Exhibit 5: Minskoff Theater

Exhibit 5B: Architectural Modifications

Exh. 5B Architectural Modifications at Minskoff Theater

5. MINSKOFF THEATER
ORCHESTRA LEVEL HOUSE RIGHT - MEN TOILET ROOM PLAN

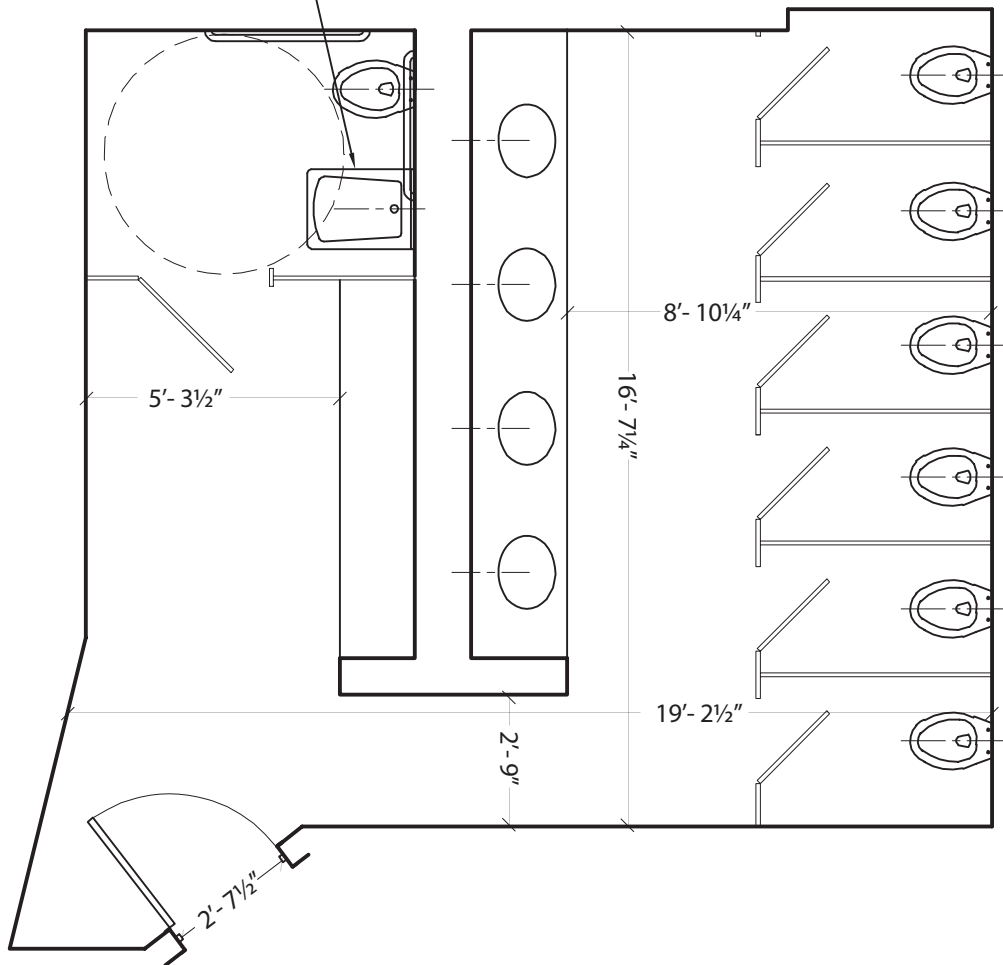
INSTALL NEW COMPLIANT
LAVATORY

5. MINSKOFF THEATER MEZZANINE LEVEL HOUSE RIGHT- MEN TOILET ROOM PLAN

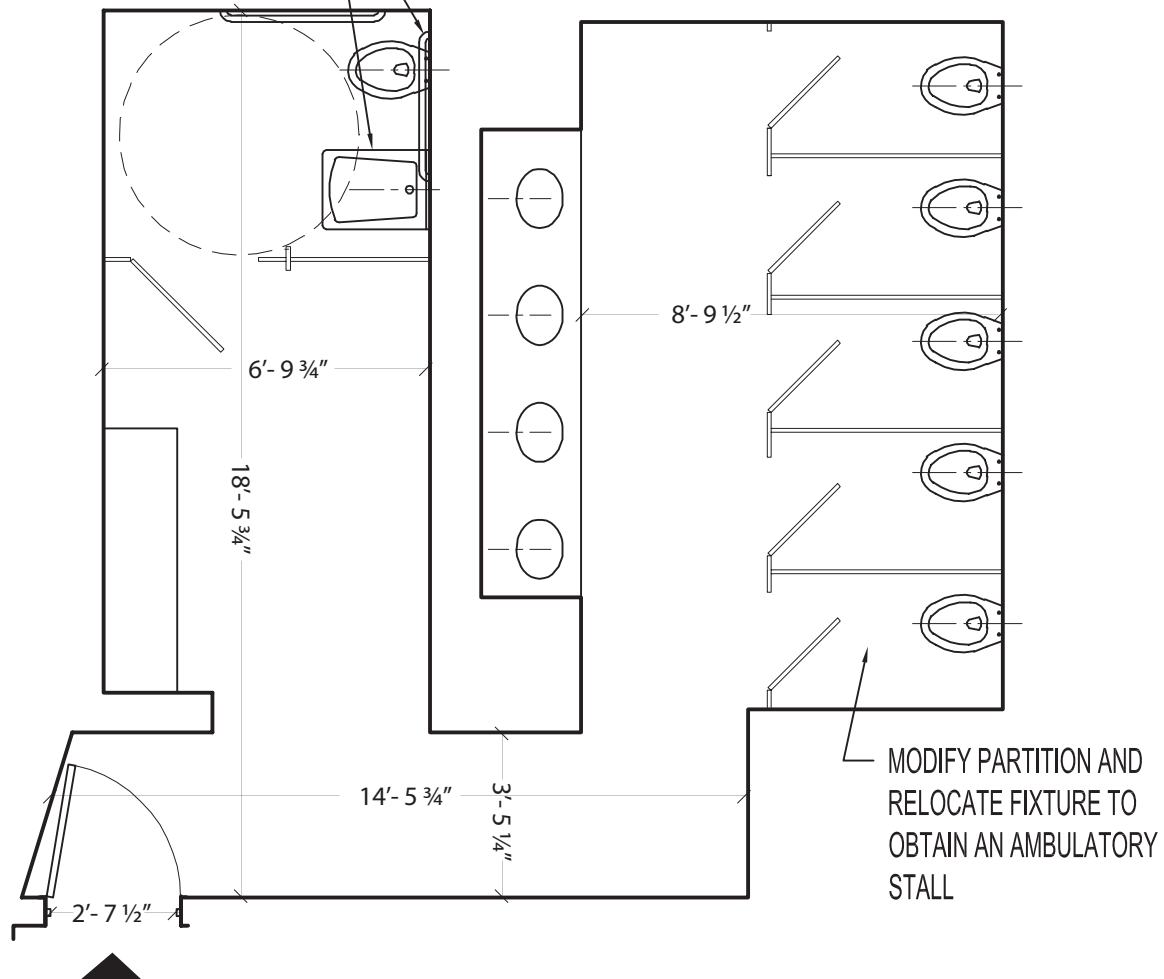
INSTALL NEW COMPLIANT
LAVATORY AND REAR GRAB
BAR

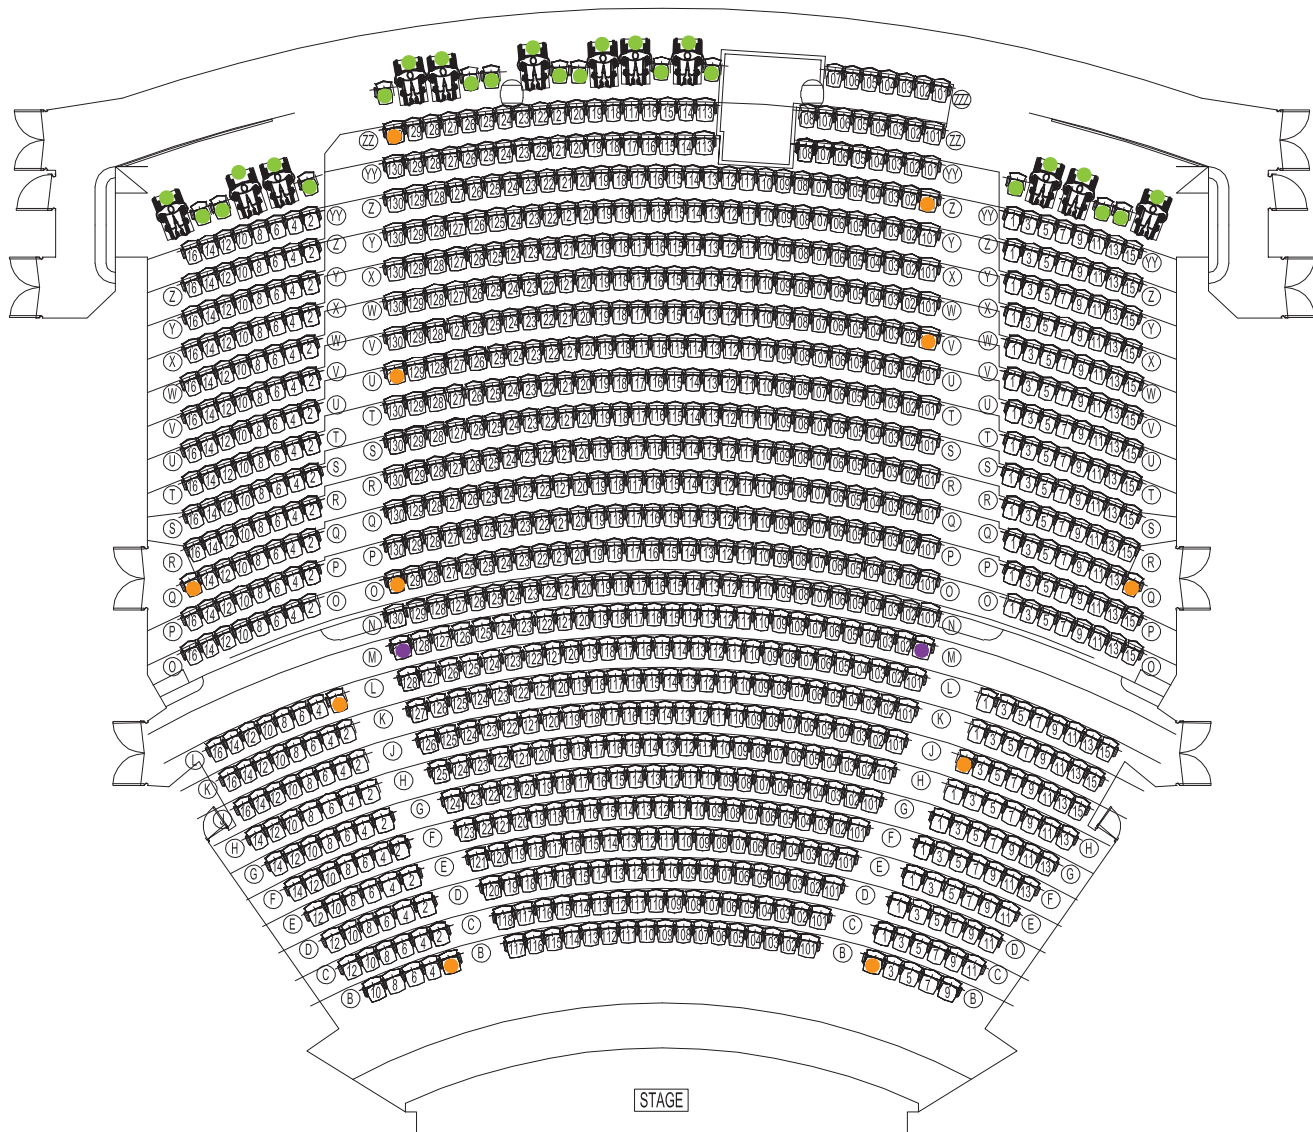
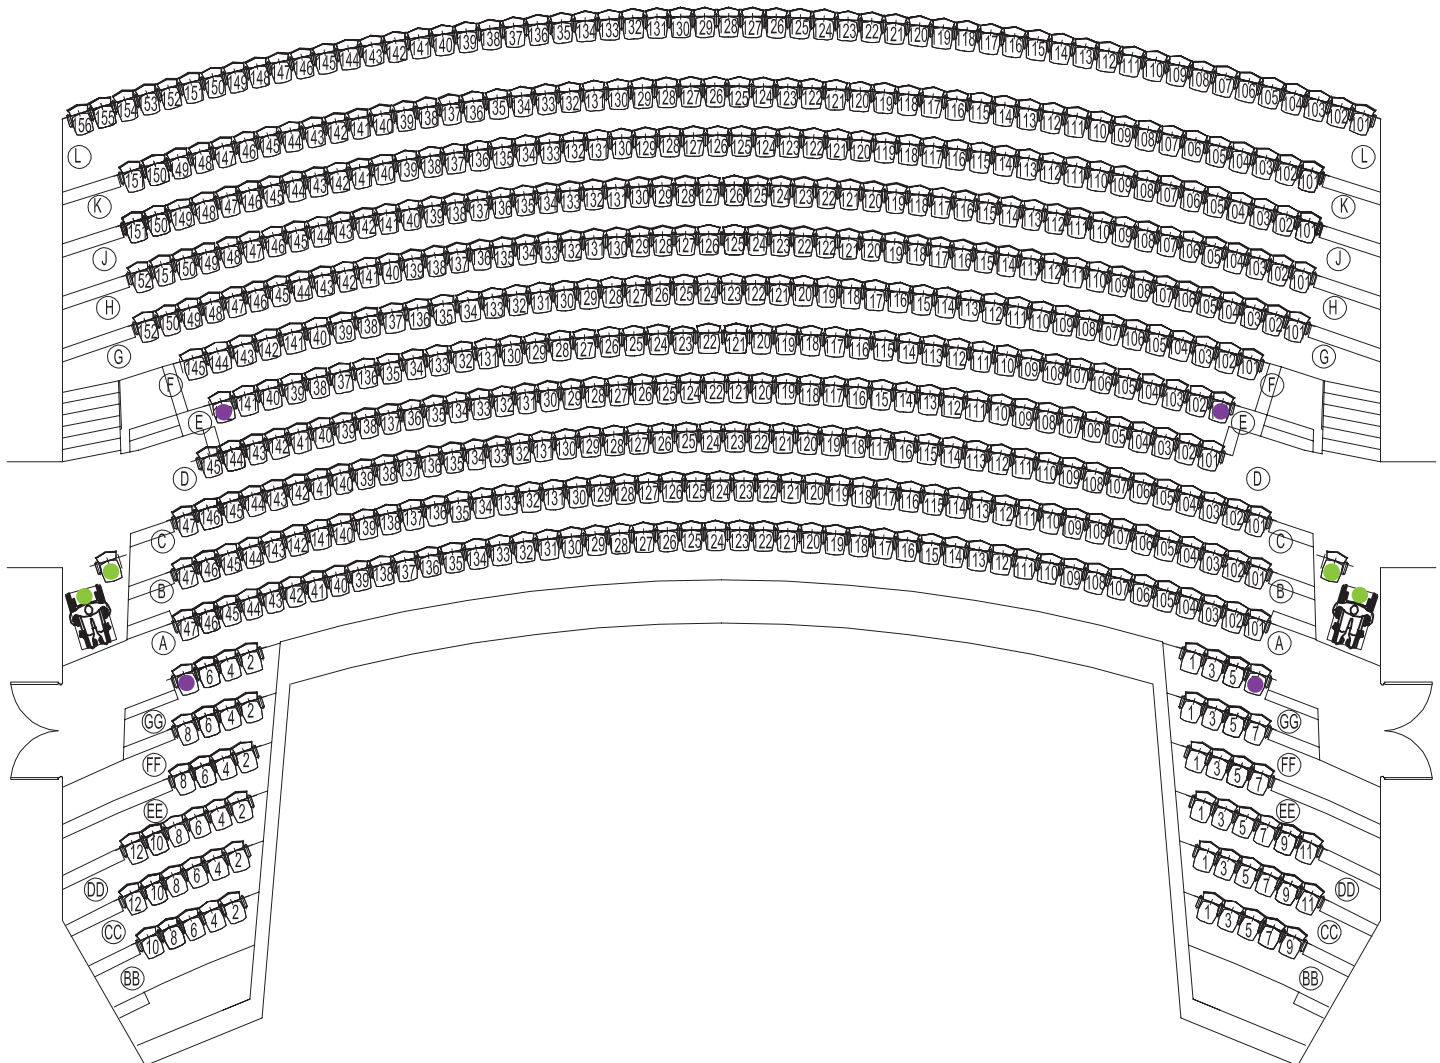
1. Nederlander shall maintain the fourteen existing wheelchair and companion seating locations on the Orchestra level: at ZZ3, ZZ7, ZZ1, ZZ4, ZZ8, ZZ12, and at ZZZ118, ZZZ120, ZZZ122, ZZZ124, ZZZ127, and ZZZ129, with ZZ1, ZZ5, ZZ9, ZZ2, ZZ6, ZZ10, and at ZZZ117, ZZZ119, ZZZ121, ZZZ123, ZZZ126, ZZZ128, and ZZZ130 being companion seating locations, and shall maintain the two existing wheelchair locations at Mezzanine box left 1-4, and Mezzanine box right 1-4, each of which has one companion seating location.

3. Nederlander shall maintain the eleven aisle transfer seating locations on the Orchestra level at B1, B2, J1, L2, O31, Q15, Q16, U130, V101, Z101, ZZ130, and add six aisle transfer seating locations on the Orchestra level at M101, M129, and on the Mezzanine level at GG7, GG8, E101, and E142.
